## MDDP & DBPS AMENDMENT

### BENT GRASS DEVELOPMENT

DATE:  
**January 2021**  
**Revised: March 2021**  
**Revised: April 2021**

**PCD-ENGINEERING REVIEW COMMENTS  
IN BLUE BOXES WITH BLUE TEXT**

Figure 3-1  
Routing Schematic  
Falcon DBPS  
El Paso County, CO

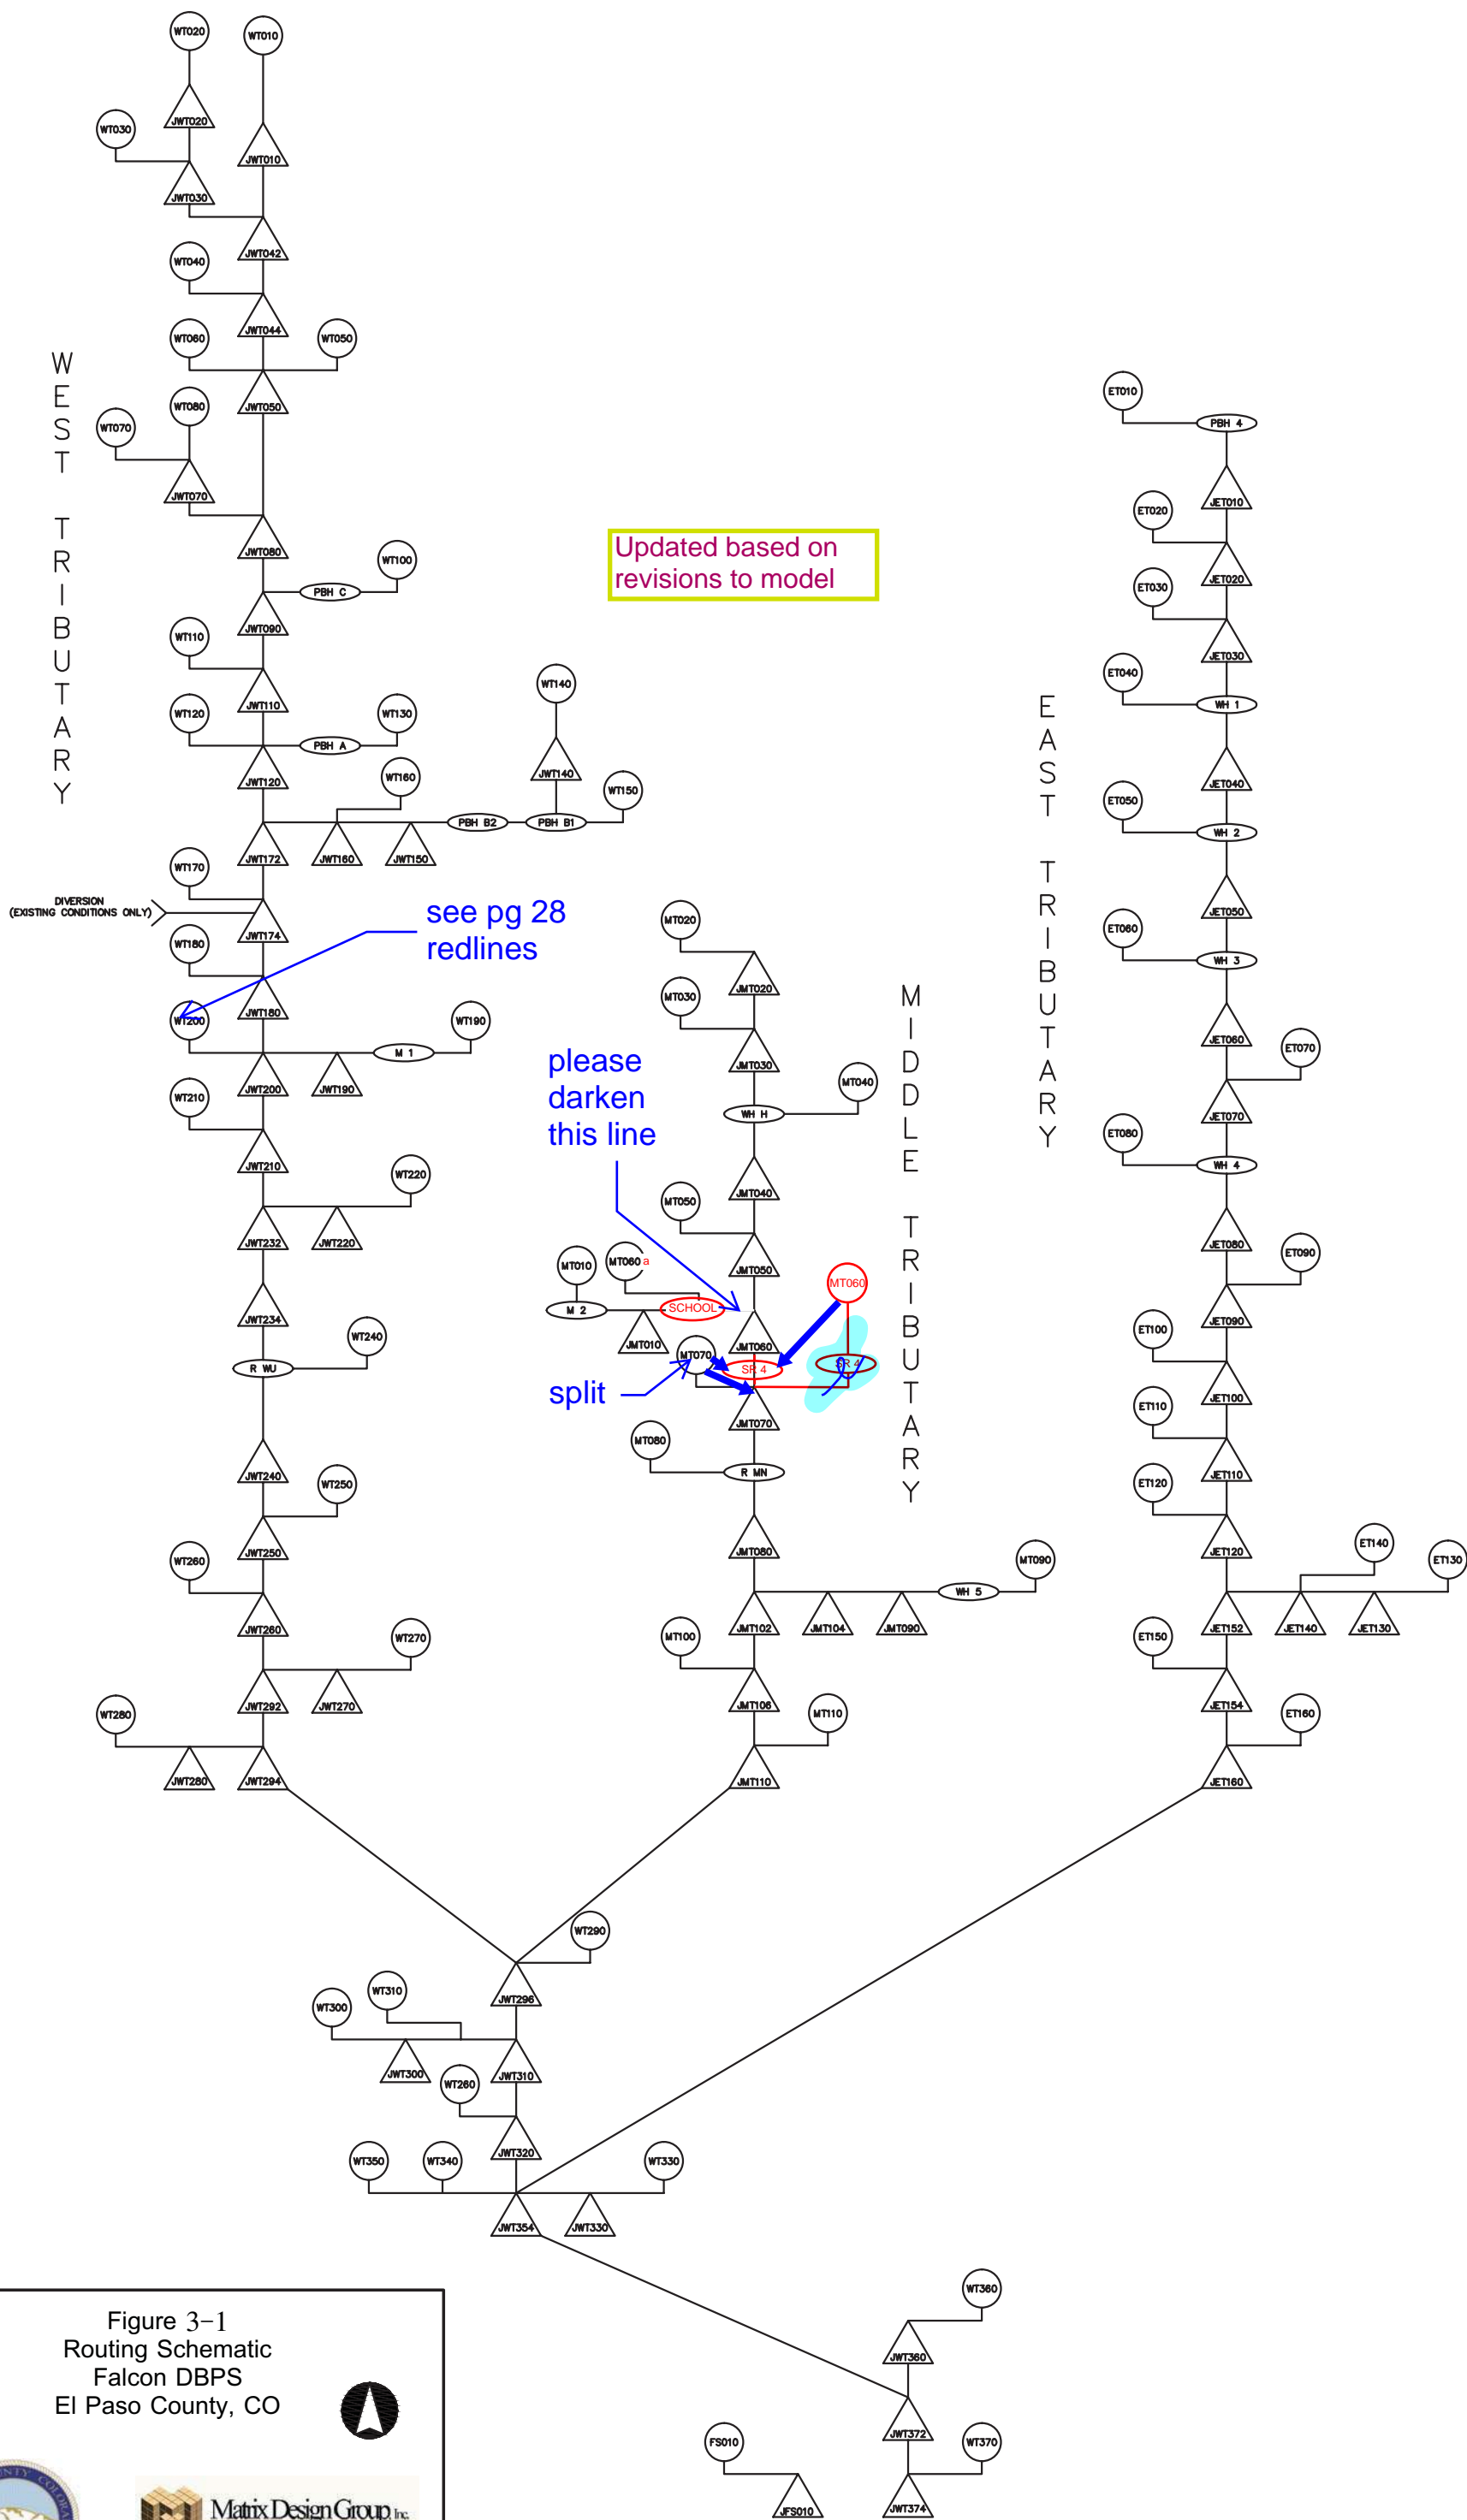
Does the model include Bent Grass Residential 2? Values don't match table on the plan.

TABLES ON PLAN HAVE BEEN UPDATED. CURRENT MODEL DOES NOT ACCOUNT FOR DEVELOPMENT IN BG R2. FUTURE MODEL ACCOUNTS FOR ALL DEVELOPMENT IN FALCON MEADOWS AND BG. TABLE ON PLAN NOW INCLUDES HMS FLOWS ENTERING & EXITING SITE (DP 40 & DP CC)

FD-2  
Sheet 2 OF 5

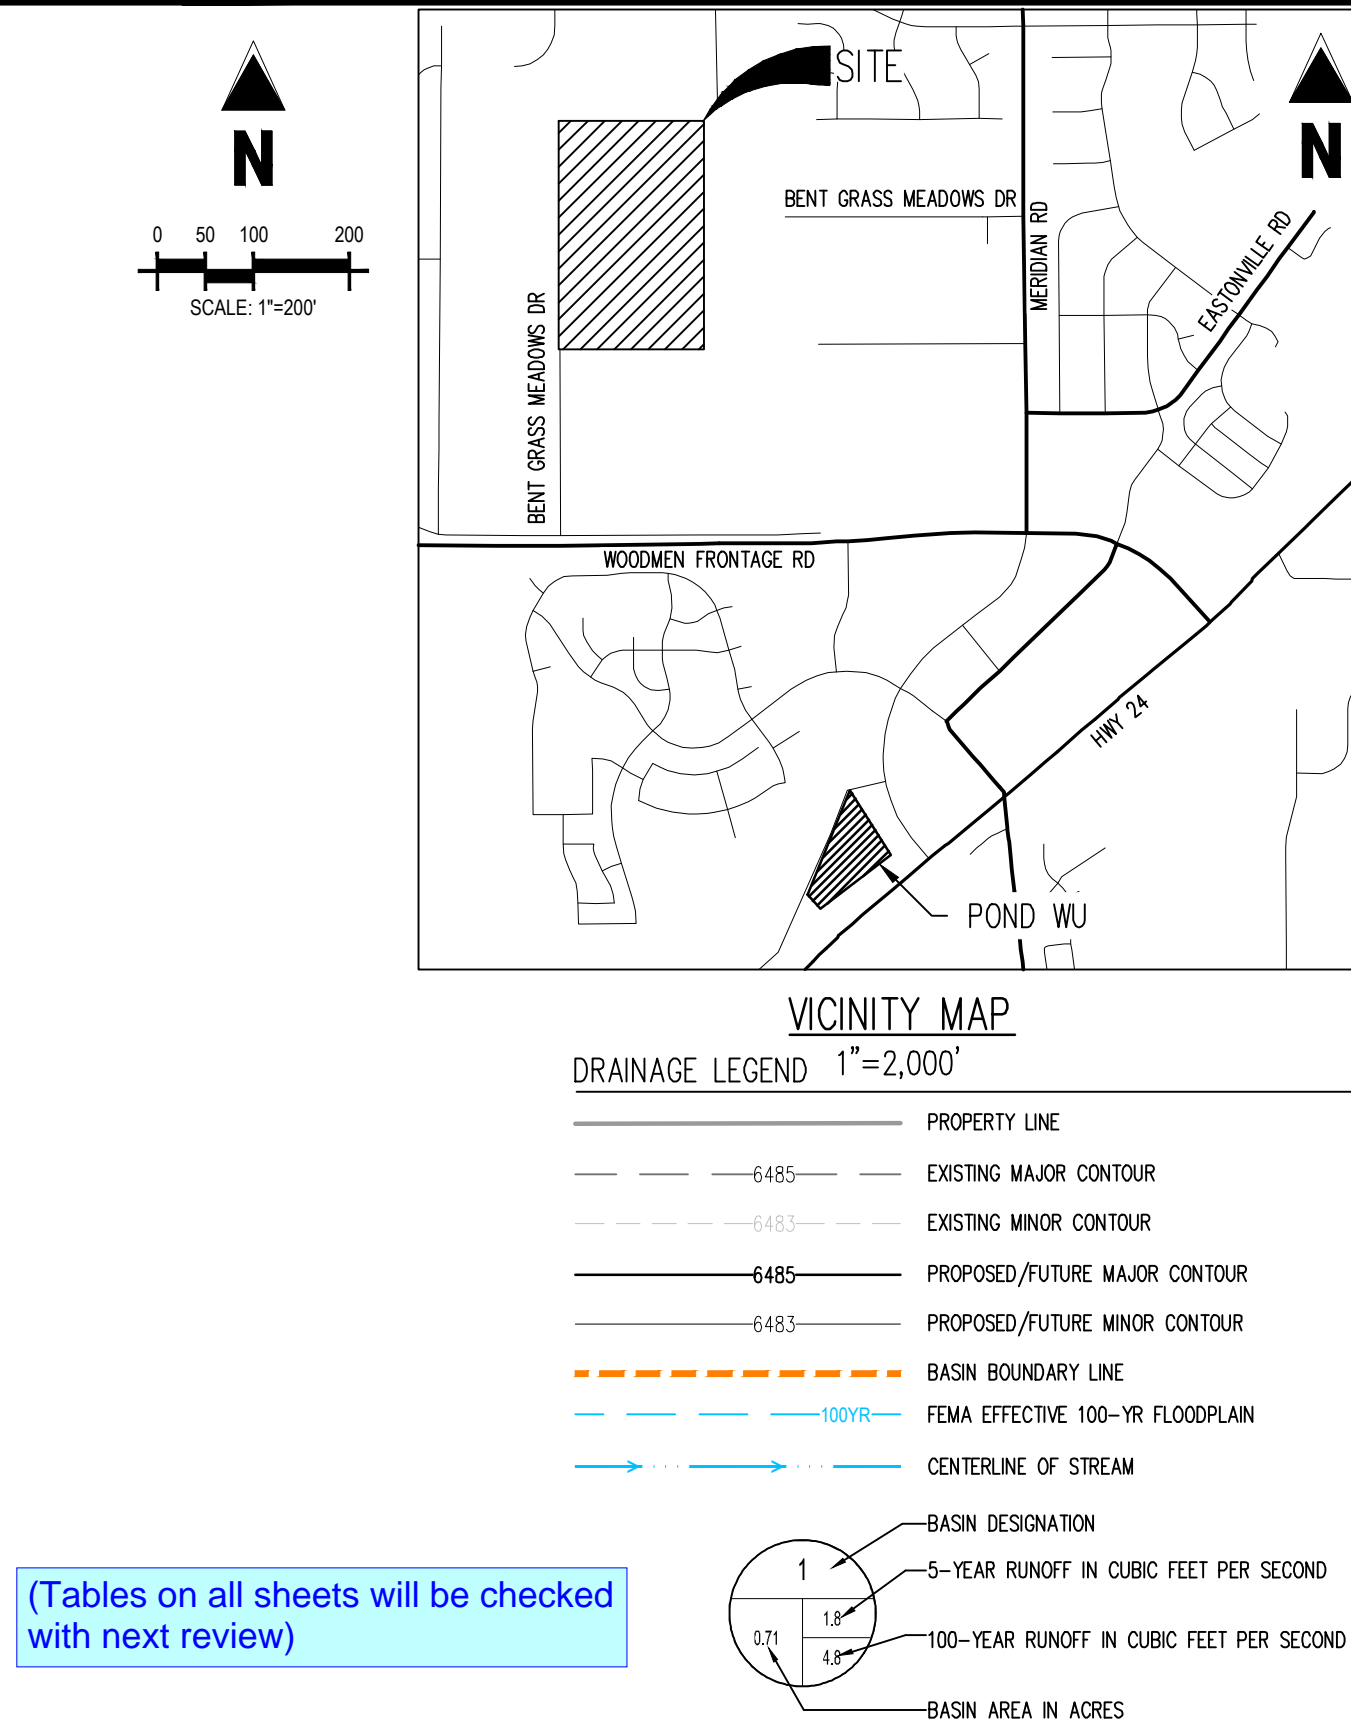
(Tables on all sheets will be checked with next review)
